Access Compliance Report Public Rights-of-Way (Pedestrian Signals)

Main Street: HEWES_AVE Cross Street: HEWES_AVE Location: SE

ADA ID: SGAT211015094805 Signal Type: One Push Button-Non APS Overall Compliance: No Severity Scores: BTN 1: 25 BTN 2: N/A No BTN: N/A

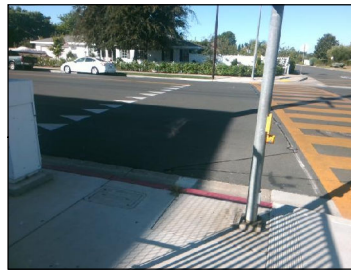
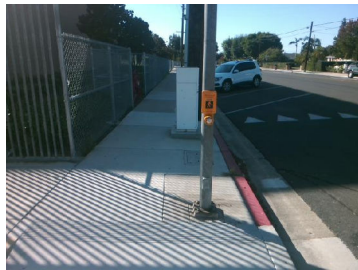
OC Std/PROW: R404.2, R404.3

Possible Solutions: Remove and Replace Clear Space.
